A. MOORE ESTATES SUBDIVISION

APPLICATION NUMBER 6 DATE May 18, 2017

APPLICANT A. Moore Estates Subdivision

DETAIL SITE PLAN

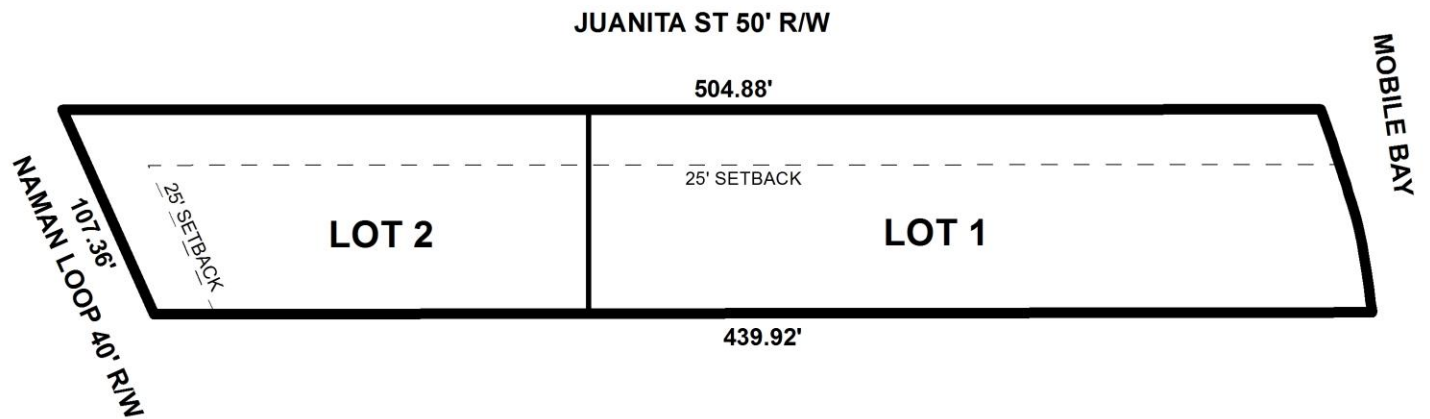
Proposed Lot 1 has frontage on Juanita Street, an unpaved minor street without curb and gutter requiring a 60' right-of-way width. Proposed Lot 2 also has frontage on Juanita Street, as well as on Naman Road, another unpaved minor street without curb and gutter requiring a similar 60' right-of-way width. The preliminary plat illustrates a 50' right-of-way along Juanita Street and a 40' right-of-way along Naman Loop; therefore, the plat should be revised to illustrate dedication sufficient to provide 30' from the centerlines of both Juanita Street and Naman Loop, if approved.

Per Section V.D.6. of the Subdivision Regulations, dedication of the corner radius at Juanita Street and Naman Loop should be required on the Final Plat, if approved.

It should be noted that Naman Loop is incorrectly labeled as "Naman Road" on the preliminary plat; therefore, the plat should be revised to correctly label Naman Loop, if approved.

As a means of access management, a note should be required on the Final Plat stating that Lot 1 is limited to two curb cuts to Juanita Street, and Lot 2 is limited to one curb cut to each street on which it has frontage, if approved; with their sizes, locations and designs to be approved by Mobile County Engineering and conform to AASHTO standards.

The preliminary plat illustrates the 25' minimum building setback line along all street frontages, as required by Section V.D.9. of the Subdivision Regulations. If approved, this information should be retained on the Final Plat, adjusted for any required dedication.

Each lot meets the minimum size requirements of the Subdivision Regulations for lots served by public water and individual septic tanks, and are appropriately labeled in square feet and acres on the preliminary plat. If approved, this information should be retained on the Final Plat, adjusted for any right-of-way dedication; or, a table providing the same information may suffice.

Finally, since both streets are substandard in terms of roadway width and surfacing, a note should be placed on the Final Plat stating that there shall be no future subdivision of the site until each road is improved in width and paved in asphalt to Mobile County Engineering standards.

- 1) revision of the plat to illustrate dedication sufficient to provide 30' from the centerline of Juanita Street;
- 2) revision of the plat to illustrate dedication sufficient to provide 30' from the centerline of Naman Loop;

- 3) dedication of the corner radius at Juanita Street and Naman Loop, per Section V.D.6. of the Subdivision Regulations;
- 4) revision of the plat to correctly identify Naman Loop;

- 5) placement of a note on the Final Plat stating Lot 1 is limited to two curb cuts to Juanita Street, and Lot 2 is limited to one curb to each street on which it has frontage, with any changes in their sizes, locations or designs to be approved by Mobile County Engineering and conform to AASHTO standards;

- 6) retention of the 25' minimum building setback line along all street frontages, adjusted for dedication;
- 7) retention of the lot sizes for each lot in square feet and acres on the Final Plat, or provision of a table providing the same information, adjusted for dedication;

- 9) placement of a note on the Final Plat stating that there shall be no future subdivision of the site until Naman Loop and Juanita Street are improved in width and paved in asphalt to Mobile County Engineering standards;
